RE: 41 FIRST STREET LONDON SW3 2LB

Our ref: MA/6154

Subject: PLANNING ENQUIRY TO APPROVED PERMISSION

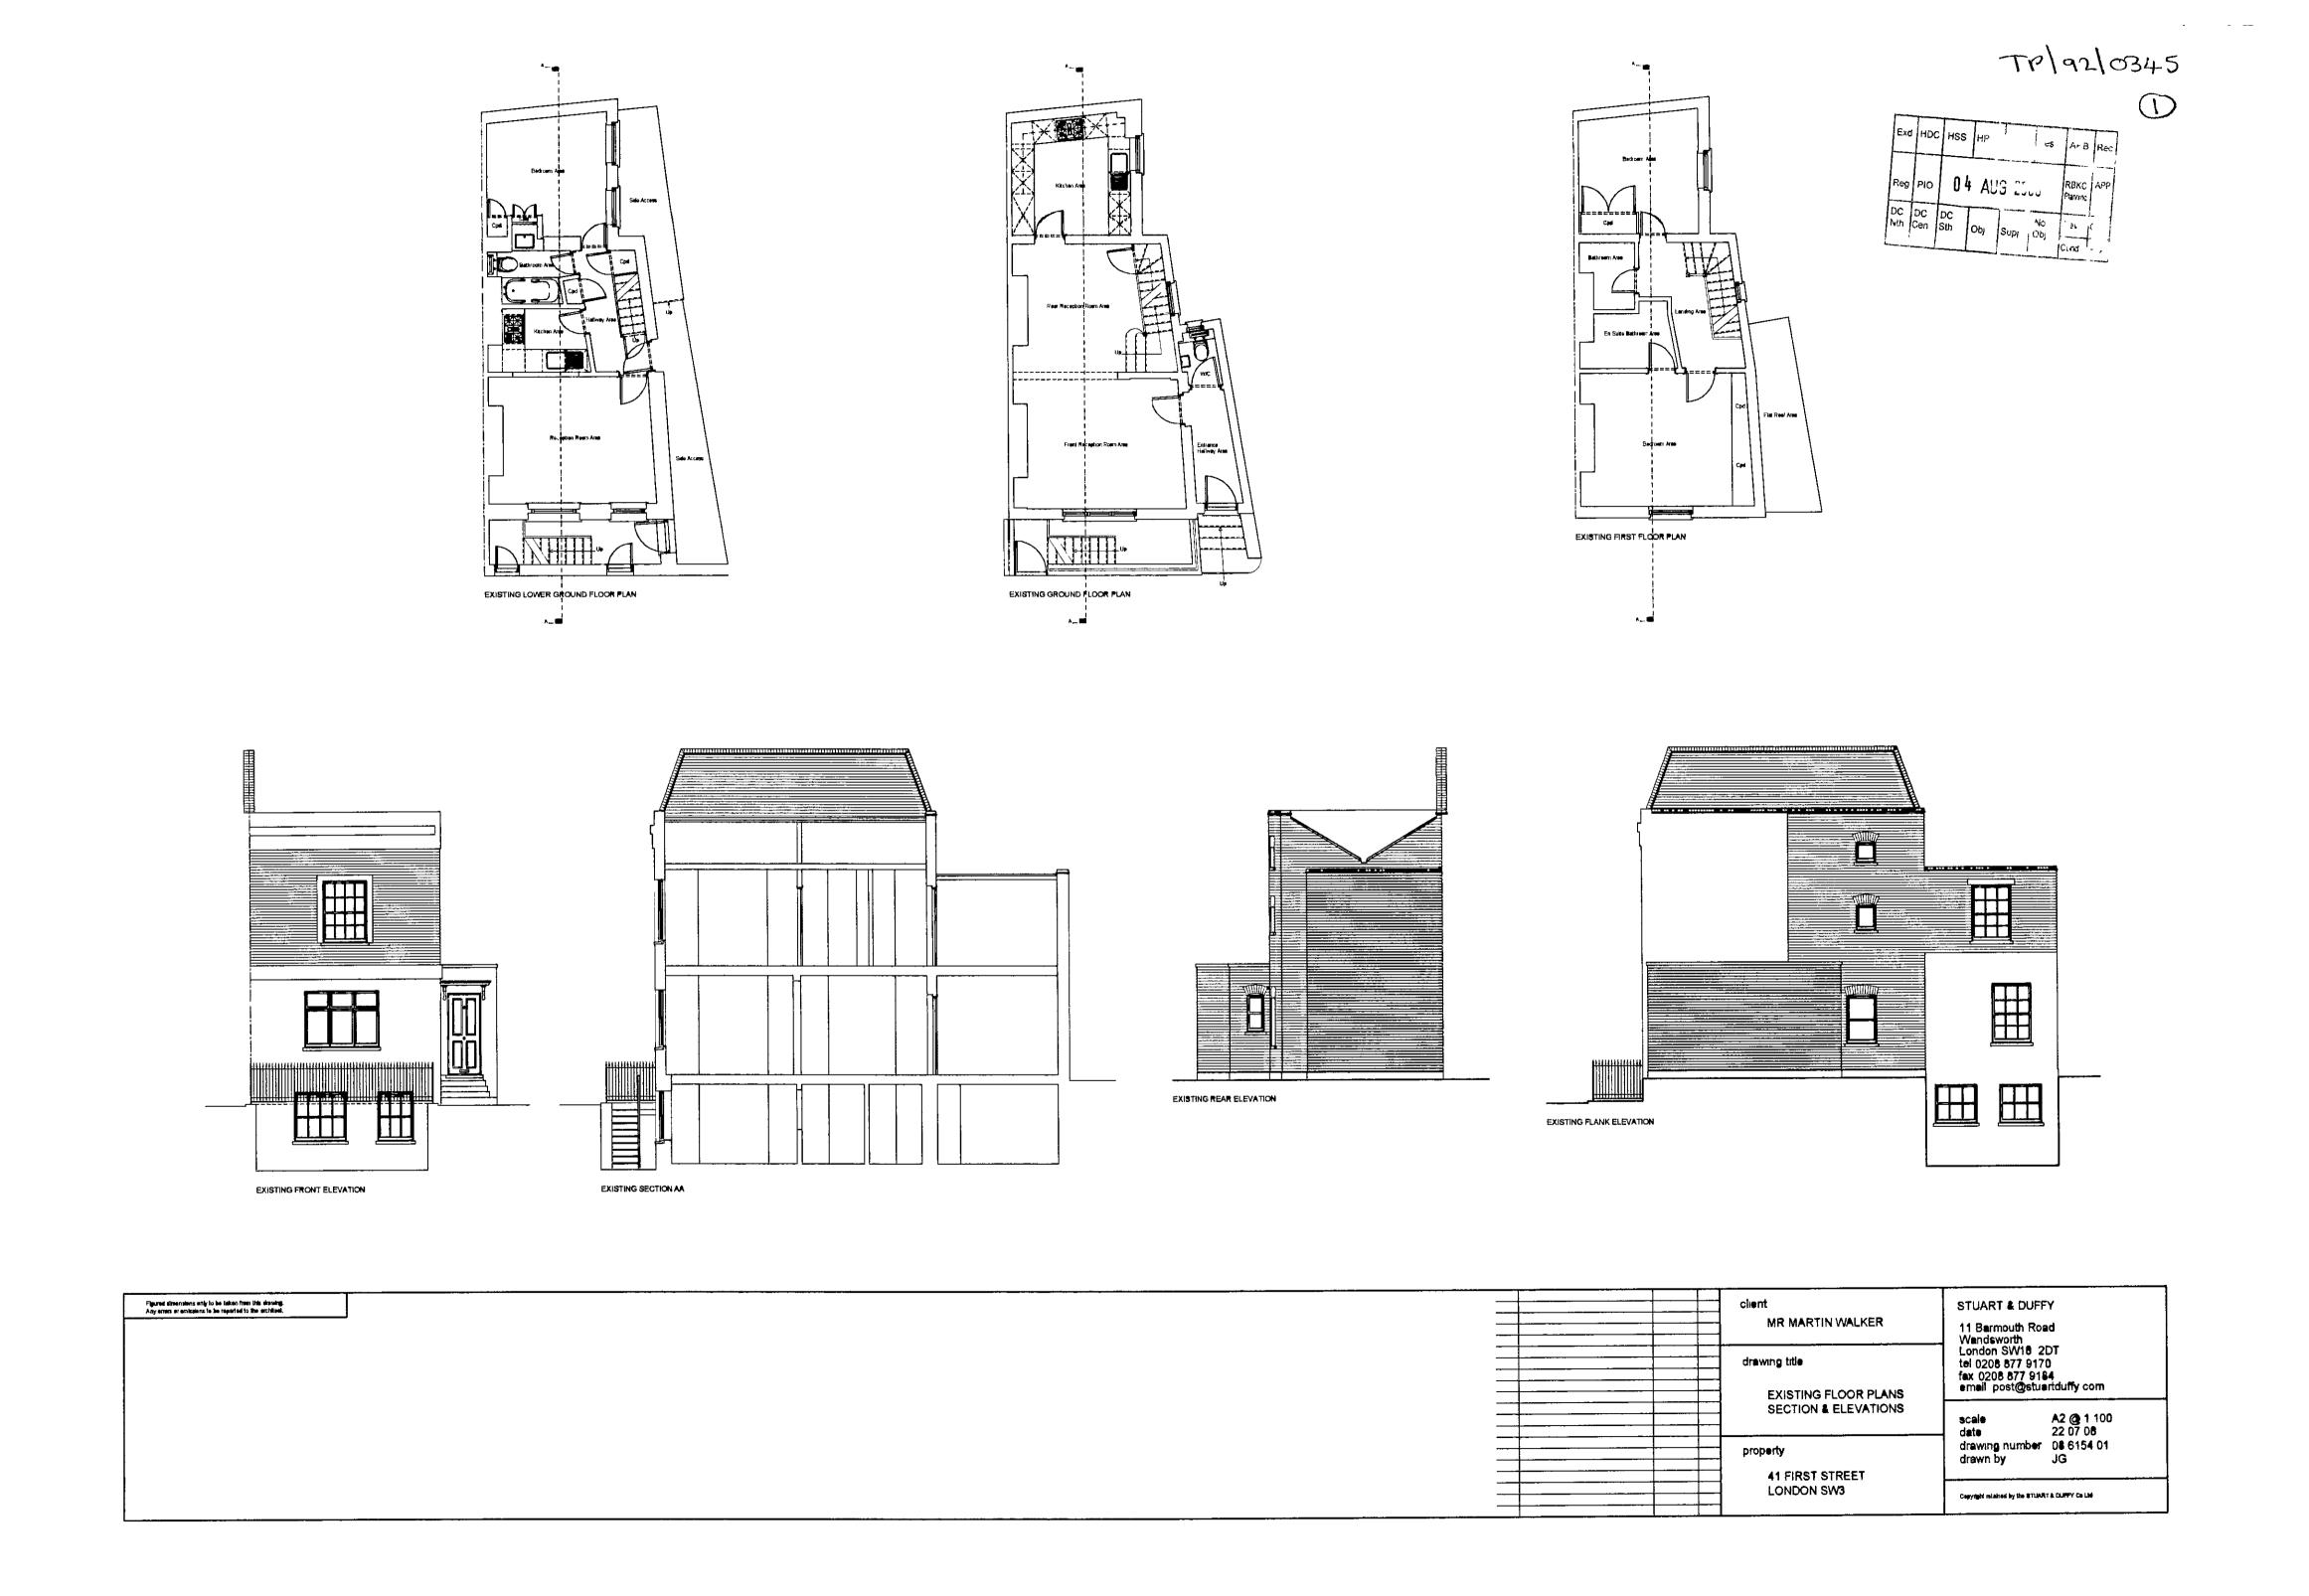
As discussed our proposed drawing shows a vertical face of brick work to the right hand flank with a mansard roof extension constructed between this and the raised section of Party Wall with no 39 First street which has a mansard roof extension. This is instead of the hipped mansard roof extension that was approved. Additionally we would also like to increase the size of the French doors down onto the rear roof terrace form a pair to a three door set which will allow more light into the rear of the property.
